# TOLEDO - LUCAS COUNTY PLAN COMMISSIONS

DATE: December 4, 2020 REF: SUP-11002-19

Amendment to Special Use Permit for Gas Station, originally approved via

1201-1211 Dorr Street

# **ELEVATIONS**

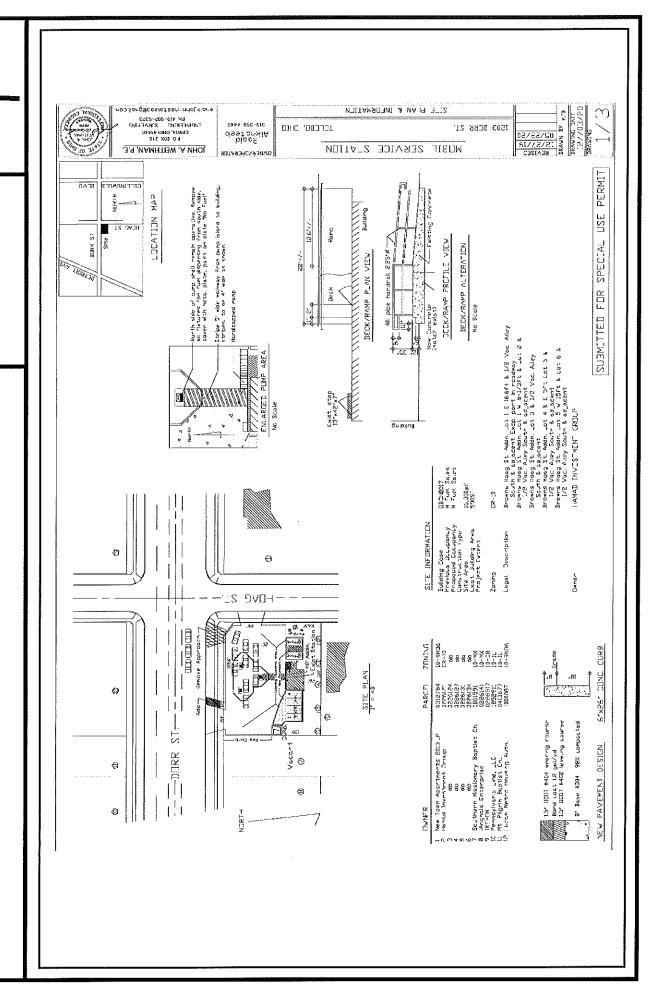
a. A building addition is proposed for the north and east facades. Building materials include a mixture of brick paneling, stucco, and windows. The design is in compliance with the zoning code.
